SYNOPSIS OF REVISIONS INCLUDED IN WATTS BAR NUCLEAR PLANT UNIT 2 DEVELOPMENTAL REVISION H OF THE TECHNICAL SPECIFICATIONS AND TECHNICAL SPECIFICATION BASES

**TENNESSEE VALLEY AUTHORITY
WATTS BAR NUCLEAR PLANT, UNIT 2**

**Revisions to Developmental Technical Specification (TS)
and Technical Specification Bases (TSB) Revision H**

FIGURE 4.3-3
MINIMUM REQUIRED BURNUP FOR UNRESTRICTED STORAGE
OF ~~NEW AND SPENT~~ FUEL OF VARIOUS INITIAL ENRICHMENTS

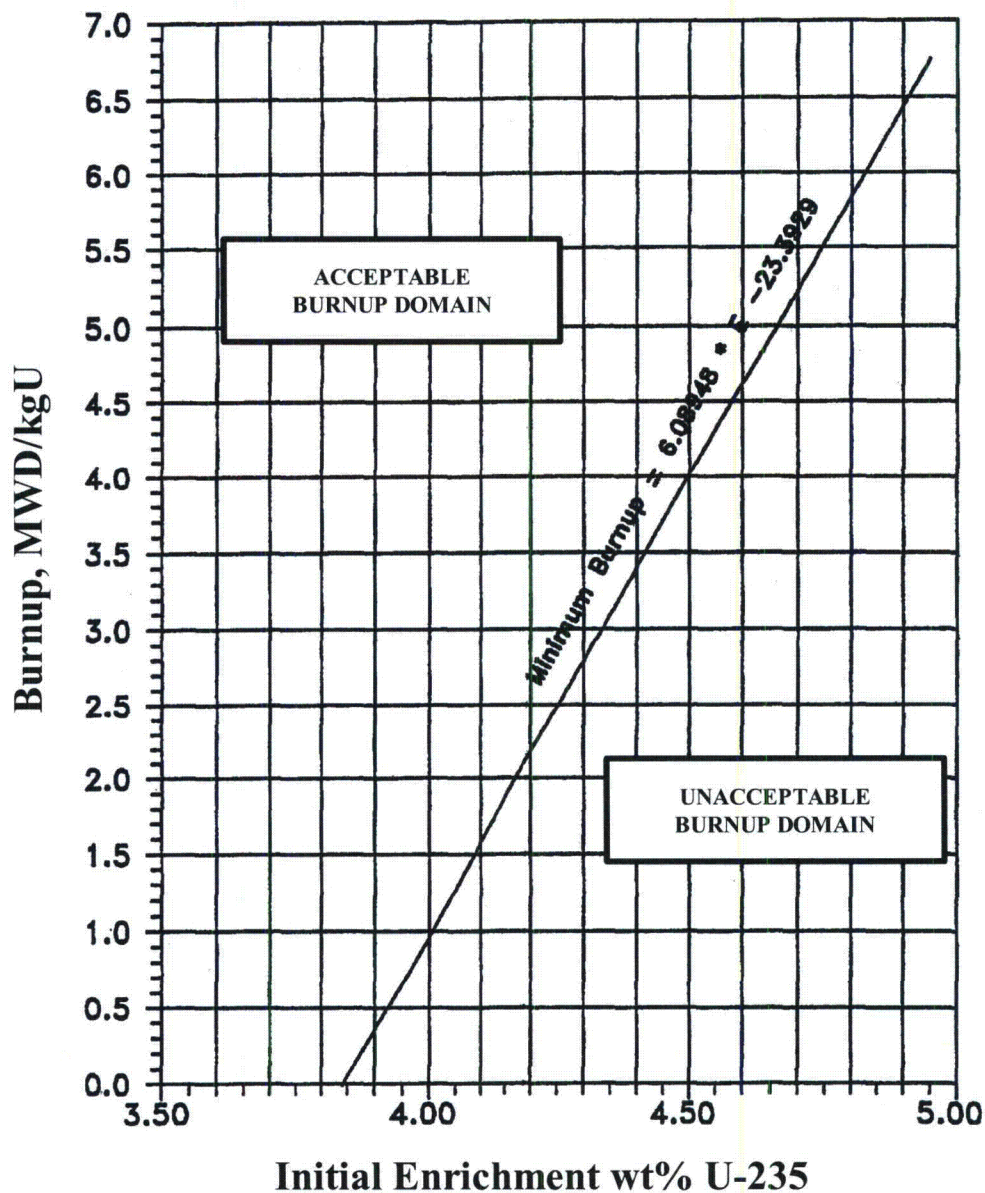
1. ~~New and spent-f~~Fuel assemblies may be stored in the racks in an all cell arrangement provided the burnup of each assembly is in the acceptable domain identified in Figure 4.3-3, depending upon the specified initial enrichment.
